## **ADDENDUM NO. 5:**

1. BIKE TRAIL BRIDGE OVER SEIBERT ROAD TRUSS AND DECK DETAILS
  - Replace Sheet 108.

SCCTD Contract No. SCC MAA ML EXT - 01  
Facilities – Double Track

St. Clair County MetroLink Extension  
Shiloh-Scott to MidAmerica St. Louis Airport

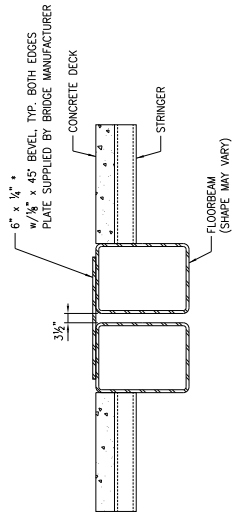
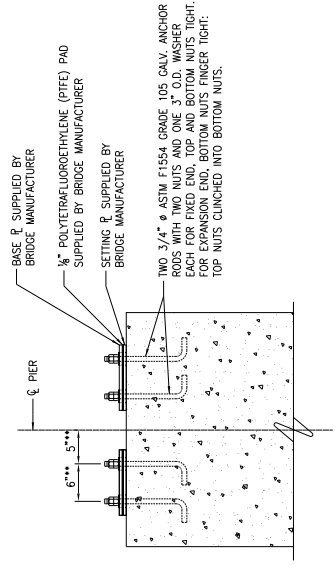
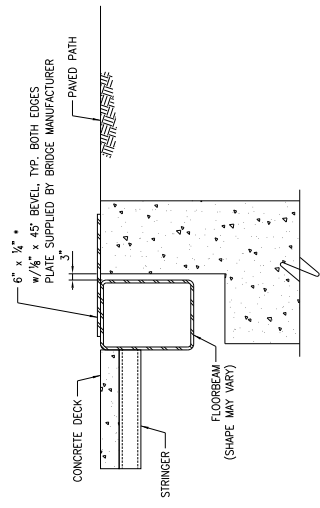
Response - Yes, the subballast extension, including the 2 inches of compacted crushed stone, is included in the Facilities – Double Track contract.
15. Question – What brand/manufacturer joint is shown/specified as shown on page 95 of the plans? Additionally, are we free to bid using the compatible joint system supplied by either manufacturer specified??

Response - Yes, limestone crushed stone that meets IDOT CA6 gradation is acceptable.
19. Question – 19.Regarding the bearing assemblies, are the thicknesses provided for the sole plates the center line thickness (so tapered sole plates need to be calculated) or are they the true thickness of the plates?

Response - The compression joint seal shown on sheet 95 is D.S. Brown Delastic. The compression joint seal may also be Watson Bowman Acme Jeene.
16. Question – There is a spec section 34 42 40 for cable trough, but I don’t see a drawing identifying where cable trough is installed or details of the trough installation. Is cable trough to be furnished and installed as part of the double track bid package?

Response - The provided dimension is for the center line thickness for the sole plates. Sole plates are tapered.
20. Question – On Page 20 & 21 of the Technical Specifications, it states that for the Monarch Butterfly Habitat Seeding, that “the exposed soil surface should be ‘hydroseeded and straw mulched with a tackifier’”. However, the section continues to state that “A 100% biodegradable erosion control blanket” is to be used. Which should be used? If both, what goes where?
